Proposal for the 02 series of amendments to Regulation No. 125

**Submitted by the expert from the Netherlands
on behalf of the Task Force on FVA***

02 series of amendments to UN Regulation No. 125

"Annex 2

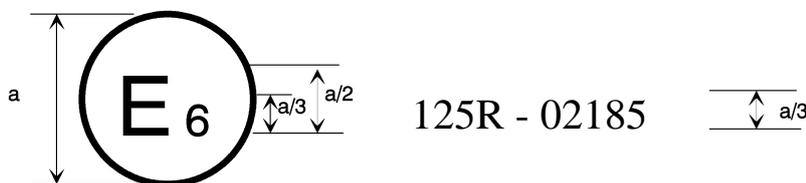
Annex 2, amend to read:

Arrangements of approval marks

The above approval mark affixed to a vehicle shows that the vehicle type concerned has been approved in Belgium (E 6) with regard to the driver's forward field of vision pursuant to UN Regulation No. 125. The first two digits of the approval number indicate that the approval was granted in accordance with the requirements of UN Regulation No. 125 as amended by the 02 series of amendments."
